Service Information

Category S	Repair Guidance	Ref. No. R018/10	Page 1 of 3
Coverage <input type="checkbox"/> Distributor only <input checked="" type="checkbox"/> Please inform your dealers		Date Issued February 19, 2010	
Please convey this information to your <input type="checkbox"/> Director <input checked="" type="checkbox"/> General Manager <input checked="" type="checkbox"/> Warranty Dept. <input checked="" type="checkbox"/> Parts Dept. <input checked="" type="checkbox"/> Training Dept. <input checked="" type="checkbox"/> Field Rep.		Date Revised	
Applicable Model RX-8 (FE/SE) with cloth-trimmed seat & manual seat lifter		Applicable Countries or Specifications Worldwide

Subject: Driver's Seat Cushion Inclines Forward when Sitting In

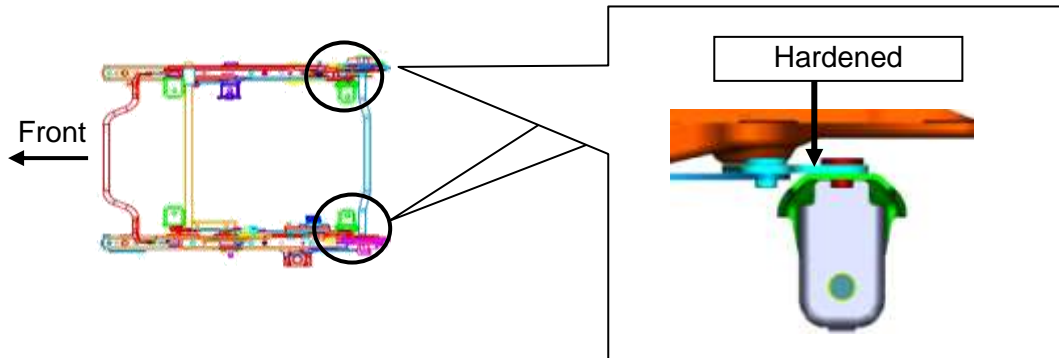
When the customer is sitting in the driver's seat with seat lifter in the full up position, some customers may experience that the driver's seat cushion gradually inclines forward.

Inadequate mechanical strength of seat adjuster unit rear link.

To increase the strength, seat adjuster unit rear link has been hardened.
